Florida Gateway College
Public Safety Complex
Engineer's Project Number L180401FGC

Addendum # 1:

TYPICAL SECTION 1

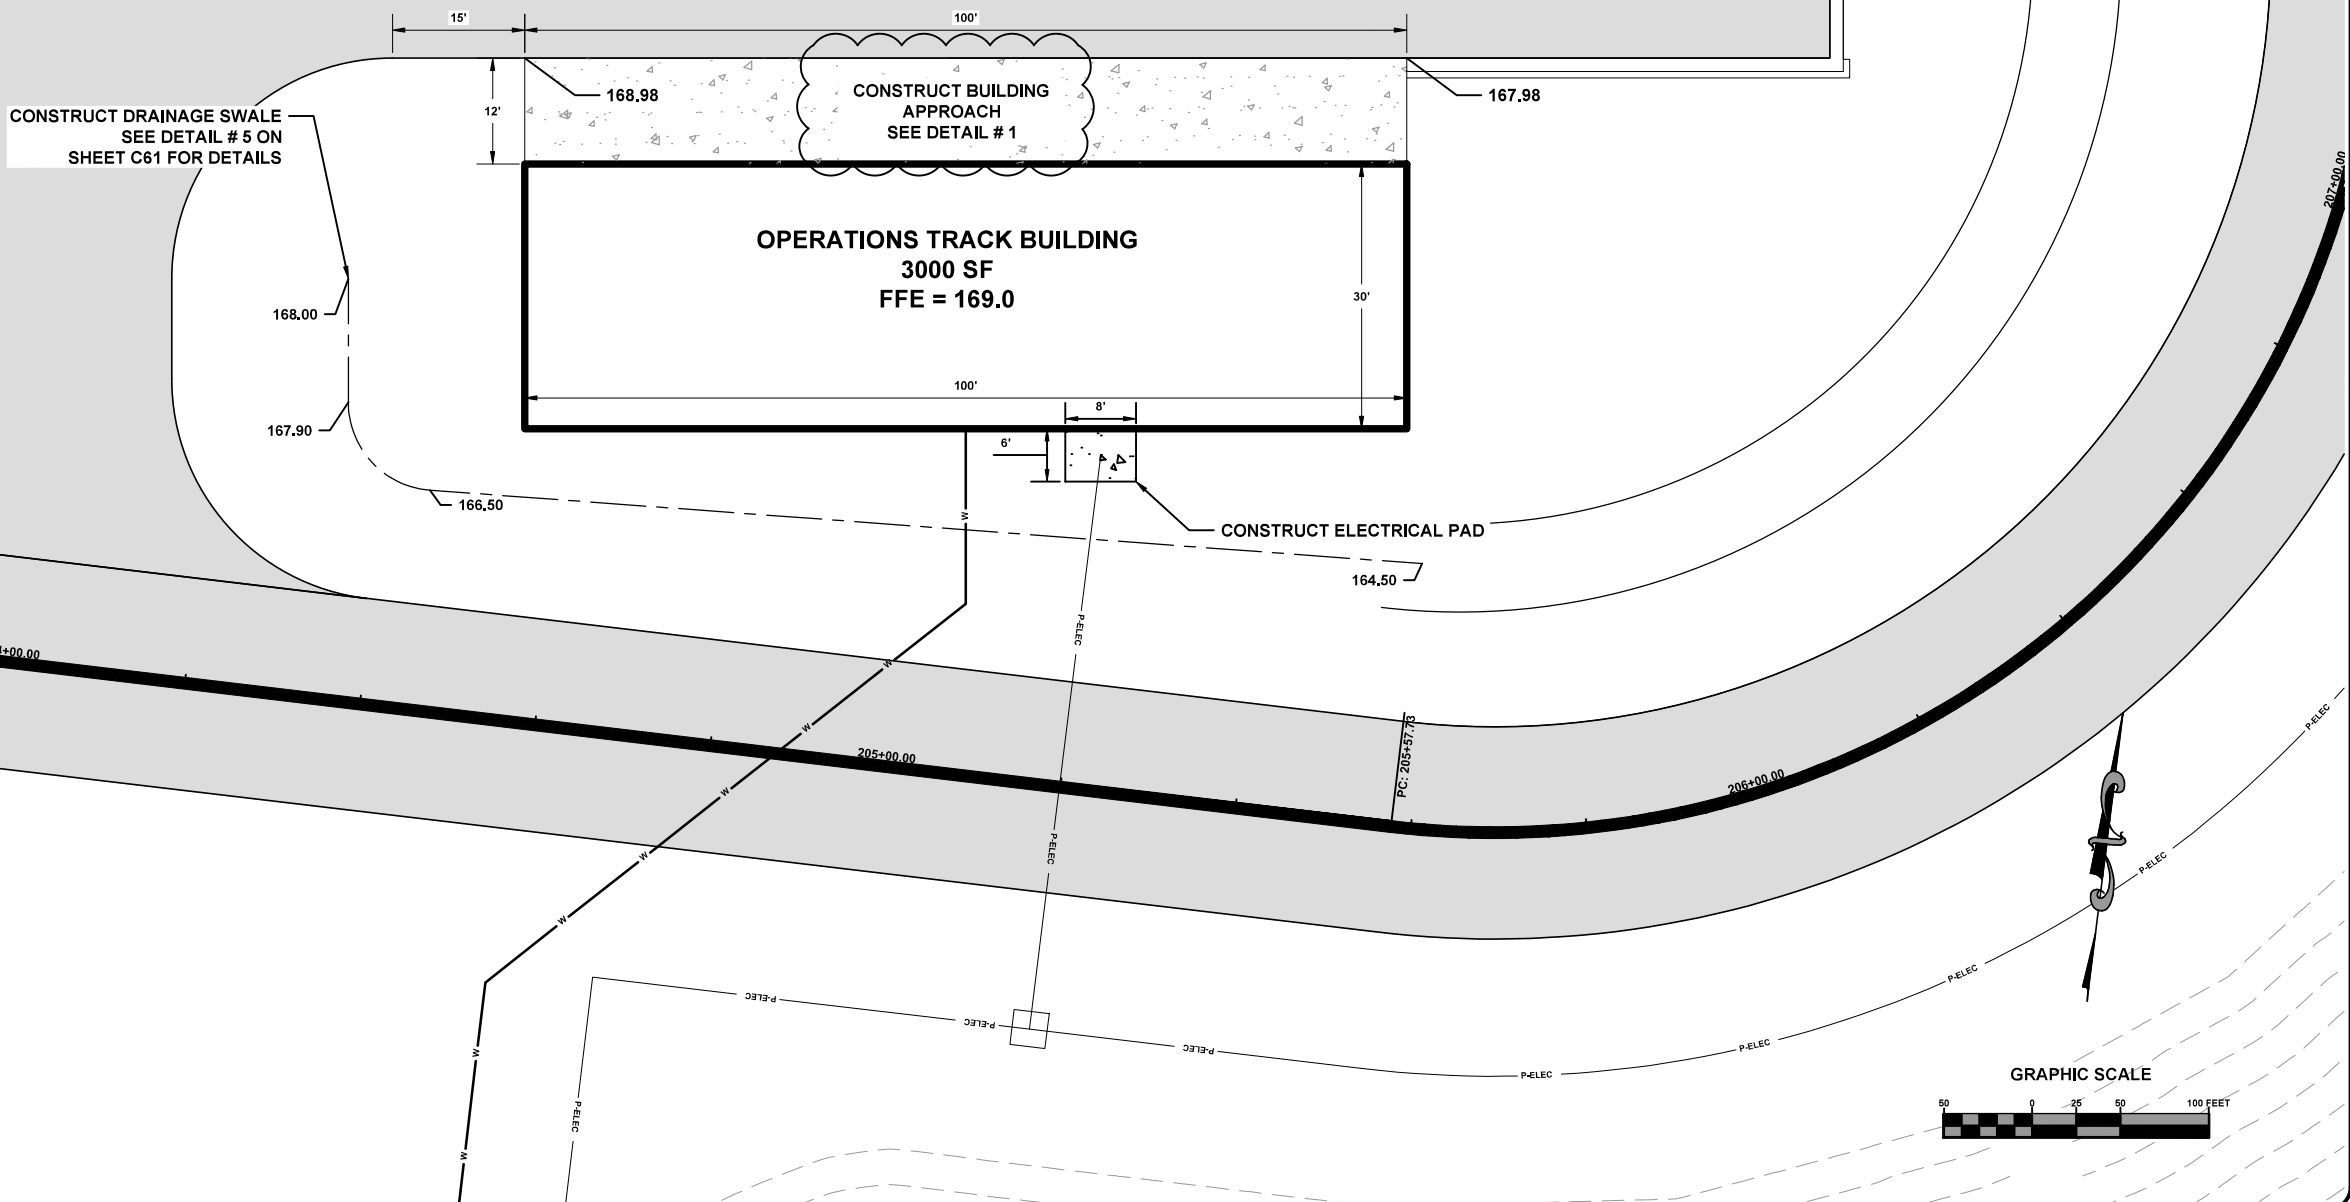
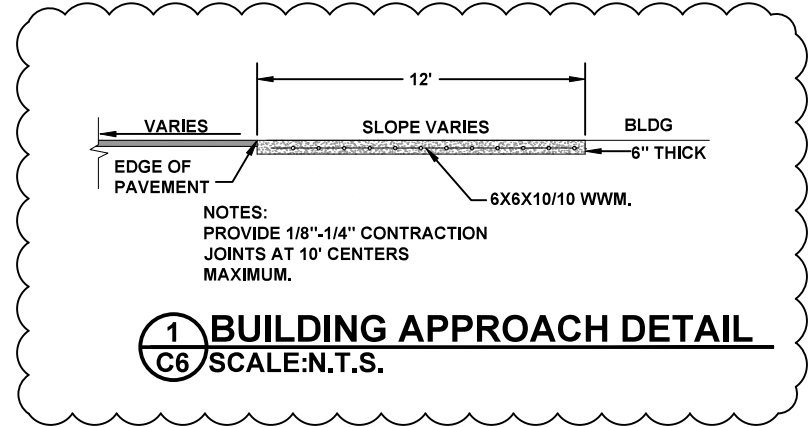
2. *The typical for the roadways calls for 2" of SP 9.5. FDOT Spec is SP 12.5 for a 2" lift Q Clarification: Should the Mix be SP 12.5, not 9.5?*
Pavement shall be SP 12.5. (see revised plan sheet)

TRAVEL LANES
 12" TYPE B STABILIZATION
 6" LIMEROCK BASE LBR 100
 TYPE SP 12.5 STRUCTURAL COURSE (TL-B) 2"

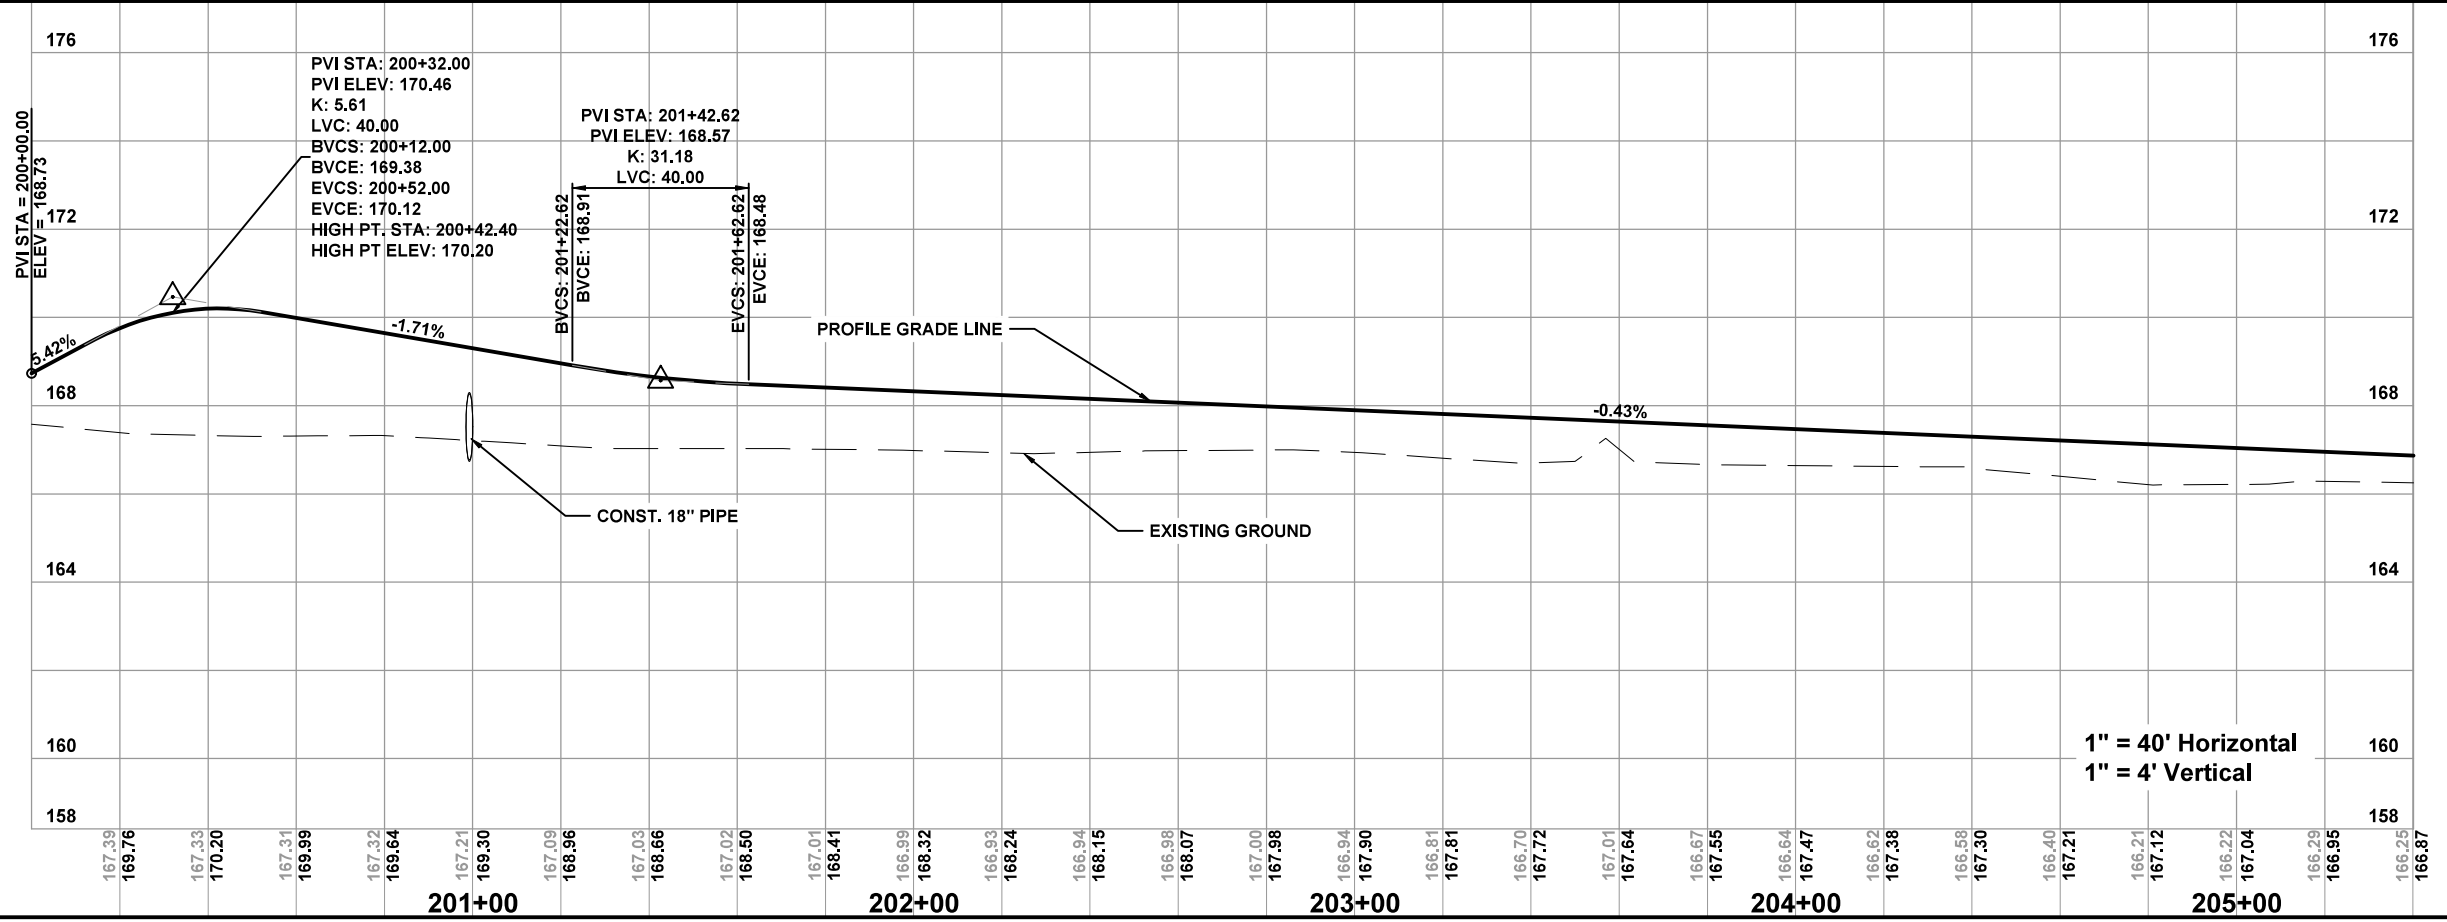
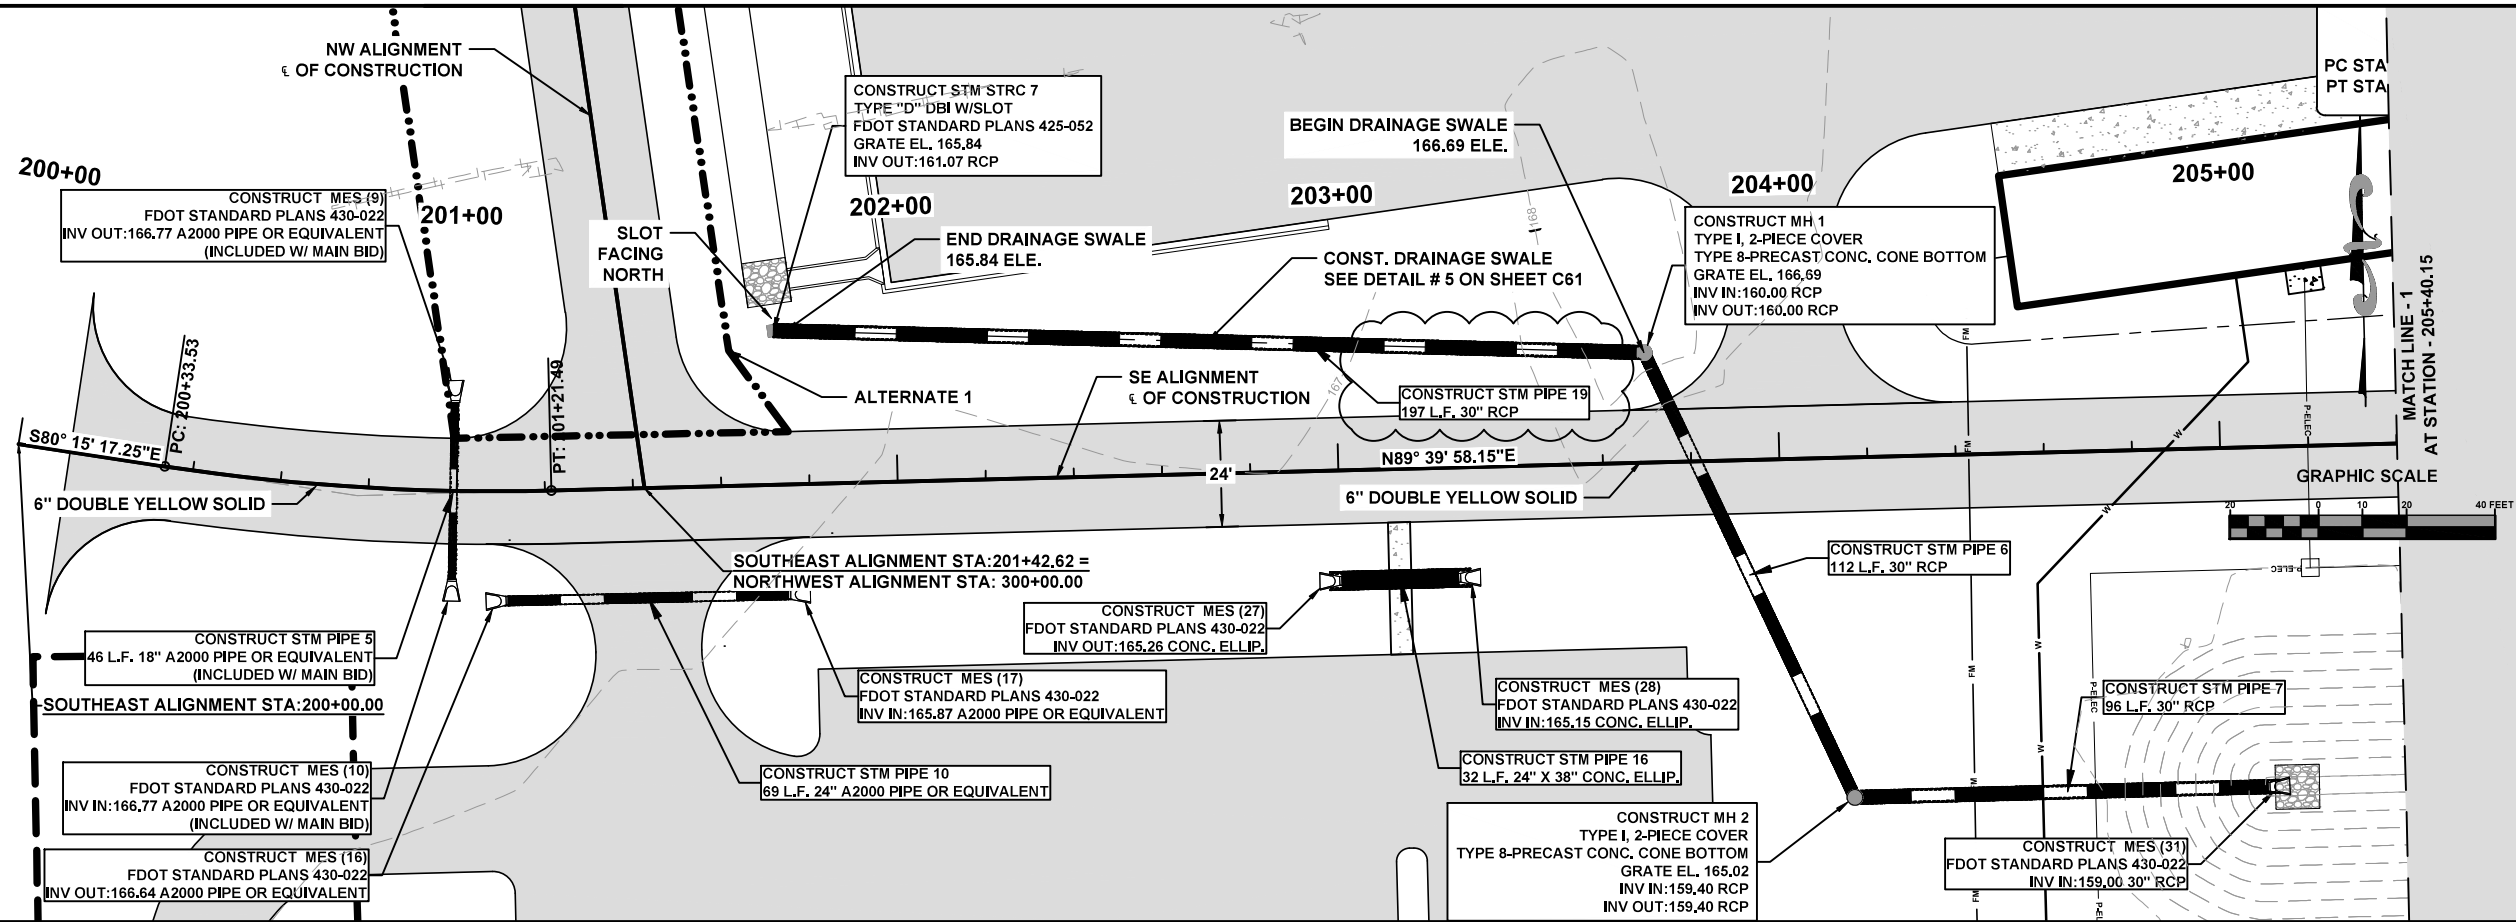
11. **Revised building approach detail to increase concrete thickness to 6". (see revised plan sheet)**

DESIGNED BY: BH	DRAFTED BY: KB	CHECKED BY: GB
DATE: 12/23/19	ENGINEER OF RECORD: GREGORY G. BAILEY	P.E. NO.: 43858
SHEET NO. C15

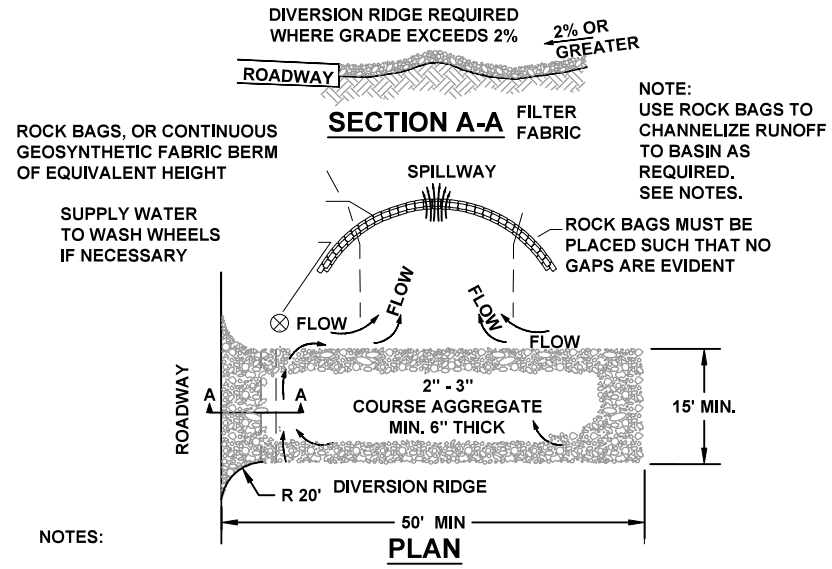
6. *What size pipe or link is needed for the southend drainage swell (pg C15)?*
The pipe shall be a 30" RCP. (see revised plan sheet)
7. *Can polypropylene pipe be used instead of what is specified?*
Polypropylene pipe may be used for all pipes that are listed as "A2000 or equivalent". All other pipes must remain as listed in plans.

REVISIONS:
 3-18-20 PIPE 19

JOB NUMBER:	L180401FGC
DESIGNED BY:	BH
DRAFTED BY:	KB
CHECKED BY:	GB
DATE:	12/23/19
ENGINEER OF RECORD:	GREGORY G. BAILEY
P.E. NO.:	43658
SHEET NO.:	C55

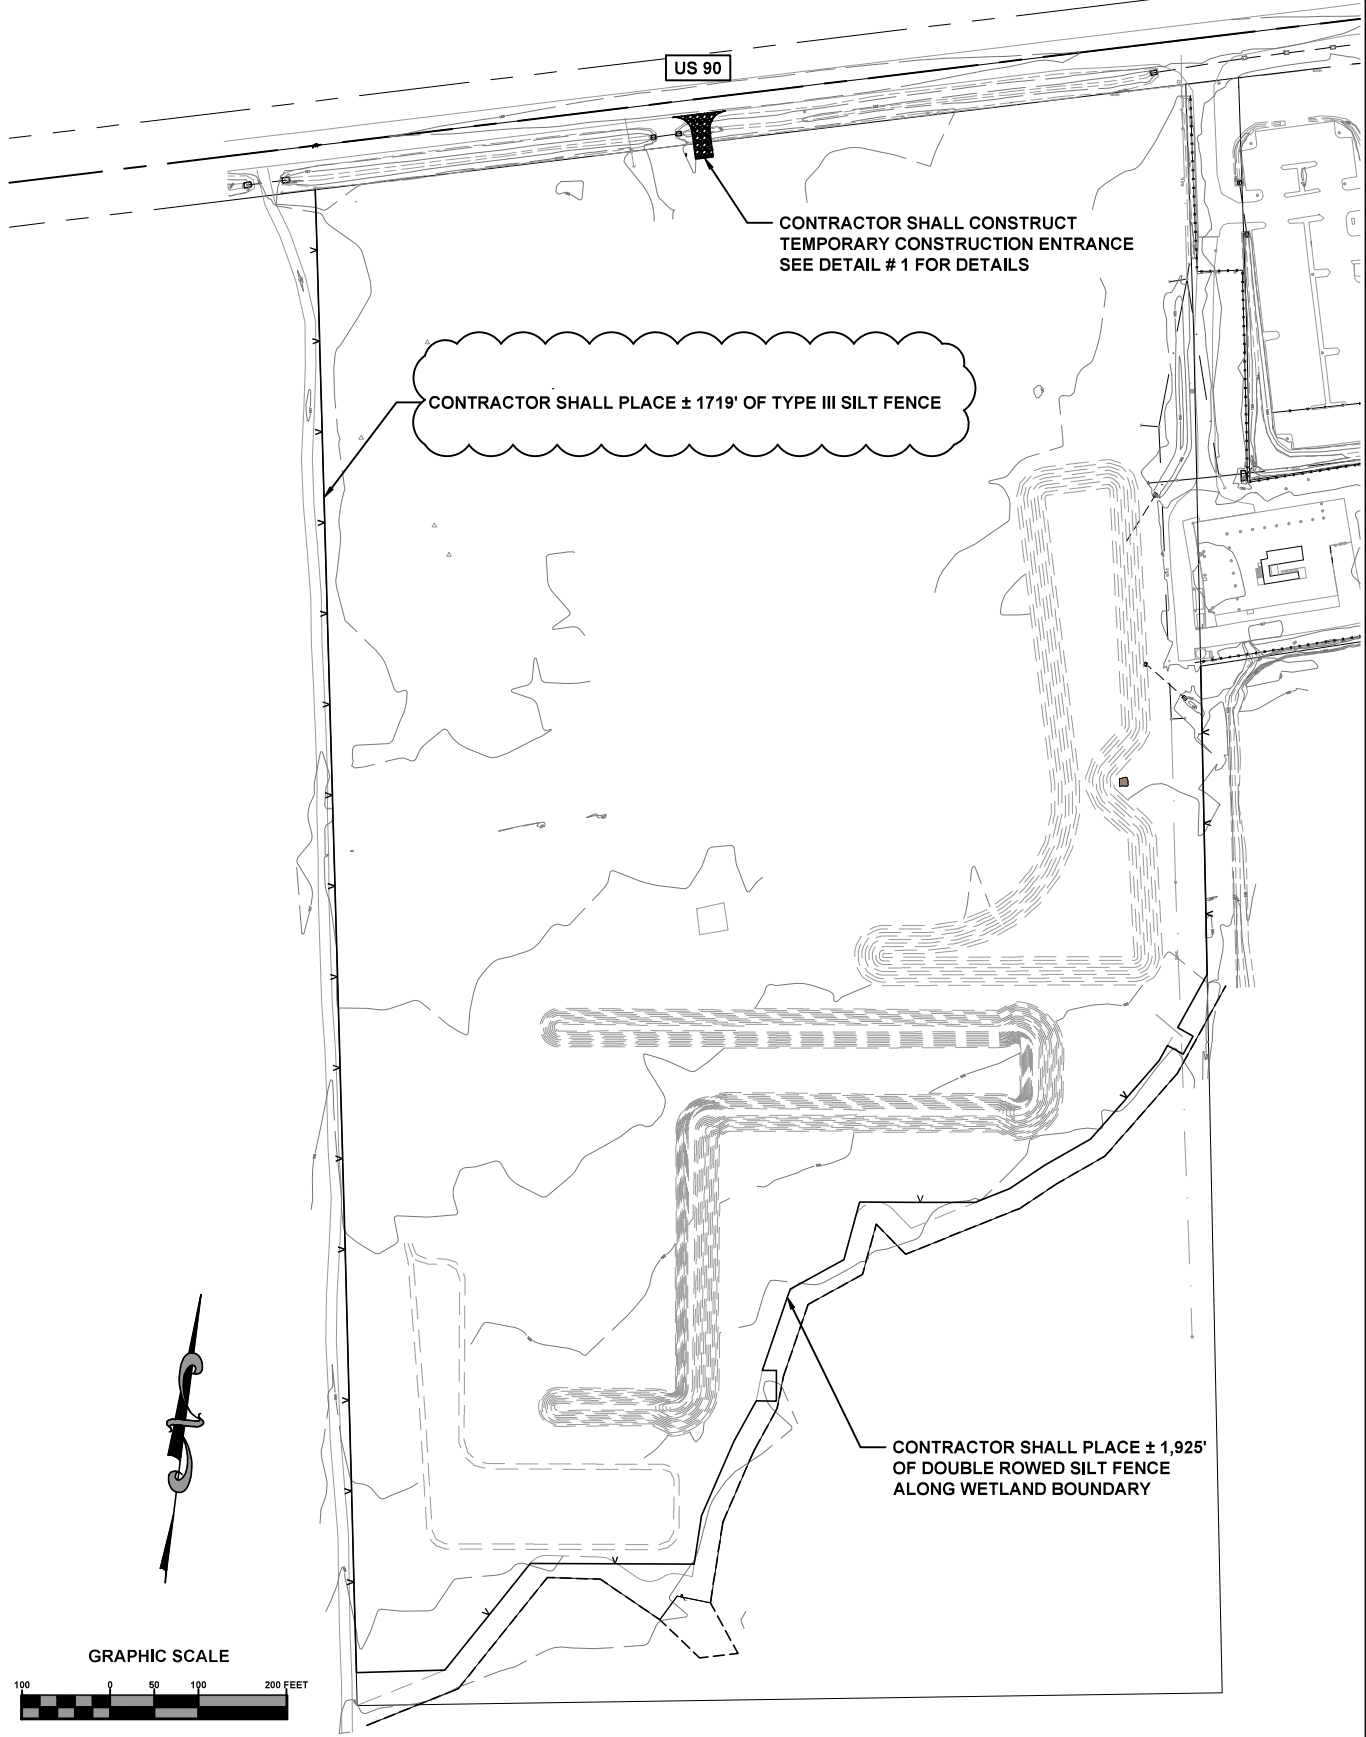
8. *Contractors shall substitute Type III silt fence in place of Type IV silt fence. Contractor is still responsible for ensuring compliance with all regulatory agencies and their requirements. Contractor to use BPM's to ensure proper erosion control.*
Type III silt fence may be used. (see revised plan sheet)

REVISIONS:
 3-18-20 SILT FENCE

5 SIDEWALK DETAIL "A"
C60 SCALE:N.T.S.

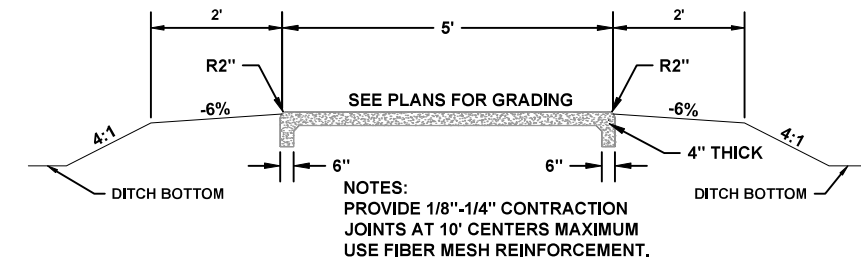
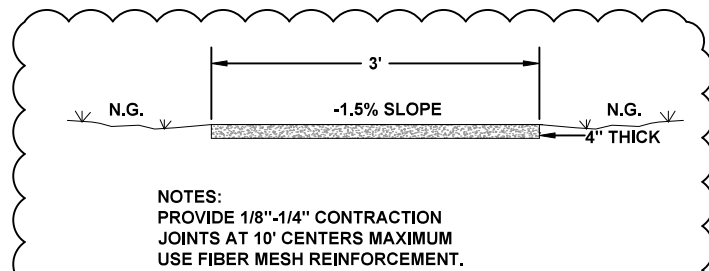
5. *The sidewalk details currently have wire mesh. Can fiber mesh be used?*
Fiber mesh may be used. Note that the approach to the operations track building shall require wire mesh. (see revised plan sheets)

REVISIONS:
 3-18-20
 SIDEWALK REINFORCEMENT
 DETAIL 9/C60

8 PARKING APRON TYPICAL SECTION
C60 SCALE:N.T.S.

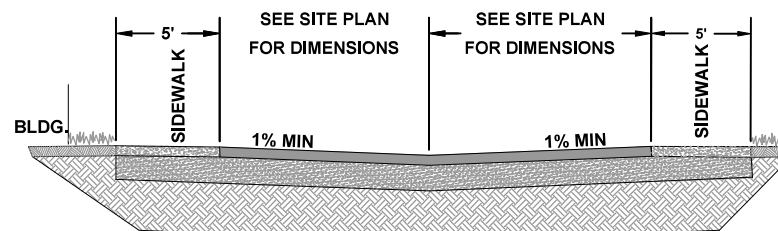
3. *8/C60 Detail for Parking calls for 1.5" SP 9.5 structure course. Q Clarification: This mix is does not require PG 76-22*
The parking area pavement does not require PG 76-22.
